SYDNEY CENTRAL CITY PLANNING PANEL COUNCIL ASSESSMENT REPORT

Panel Reference	2017SWC139
DA Number	DA/171/2014/A
LGA	City of Parramatta Council
Proposal	Section 4.55(2) Modification to approved mixed-use tower development including 2 additional residential levels, 2 additional basement levels, 59 additional basement car parking spaces, reconfiguration of podium including additional mezzanine level, revised residential apartment mix and revised stratum subdivision.
Street address	12-14 Phillip Street and 331A - 339 Church Street, Parramatta NSW 2150
Property Description	Lots 1 and 2 DP791693, Lot 3 DP825045 and Lot A DP333263
Applicant	PccDevco1 Pty Ltd
Owner	City of Parramatta Council and Roads and Maritime Services
Date of Lodgement	21 November 2017
Number of Submissions	14
Recommendation	Refusal
Regional Development Criteria (Schedule 4A of the EP&A Act)	Pursuant to Clause 21 of State Environmental Planning Policy (State and Regional Development) 2011, the proposal is a Section 4.55(2) modification to an application with a capital investment value of more than \$20 million.

Report Prepared By	Claire Jones & Robert Power, Advisian (Independent Planners)
Date	30 August 2018

Figure 3 – Proposed Modified Site Plan (Source: Marchese Partners, 2018)

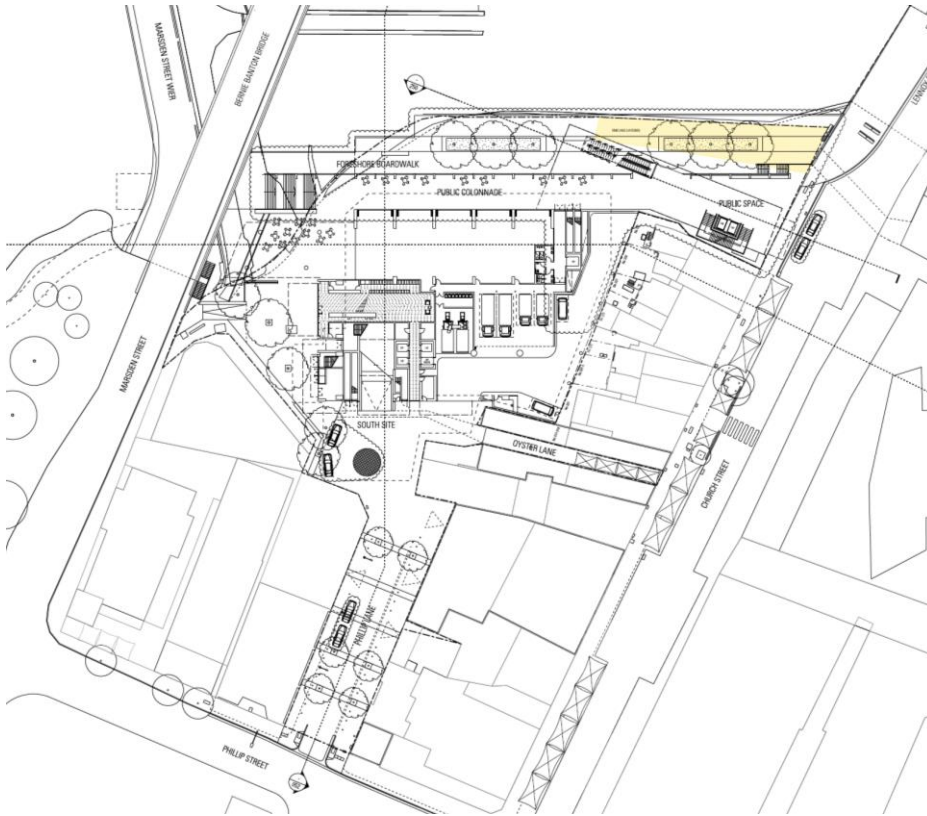
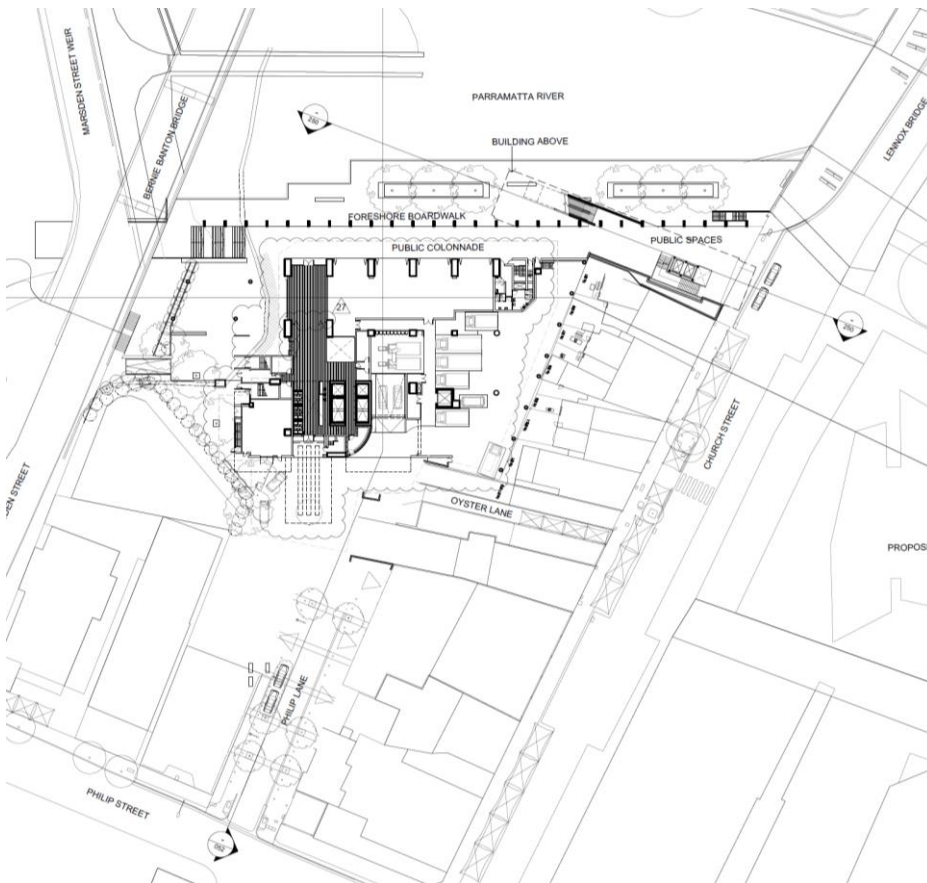
Notwithstanding the above, an assessment of the Modification Application against the provisions of Section 4.55(2)(a) of the EP&A Act raises fundamental concerns, in relation to whether the Modification Application can be determined by the consent authority to be “...*substantially the same development as the development for which consent was originally granted*...”. The Applicant’s submission was reviewed and assessed against the relevant legislative and statutory planning provisions and was guided by the relevant Land and Environment Court judgements and Court of Appeal decision cited (refer to Section 6.4 of this report).

The key modifications that are considered to fundamentally change the form, scale and configuration of the approved development from a “quantitative” and “qualitative” assessment are:

- Increase in depth of excavation for the basement from RL -14.00 to RL -16.22 for the creation of two new basement levels.
- Increase of 59 residential parking spaces.
- Reconfiguration of Basement Levels B1 to B3 for conventional car parking and Levels B4 to B9 for mechanical car stacker parking facilities.
- Addition of two residential levels.
- Provision of 23 additional apartments.
- Creation of a mezzanine level (541m²) above Level 2 Conference Centre.
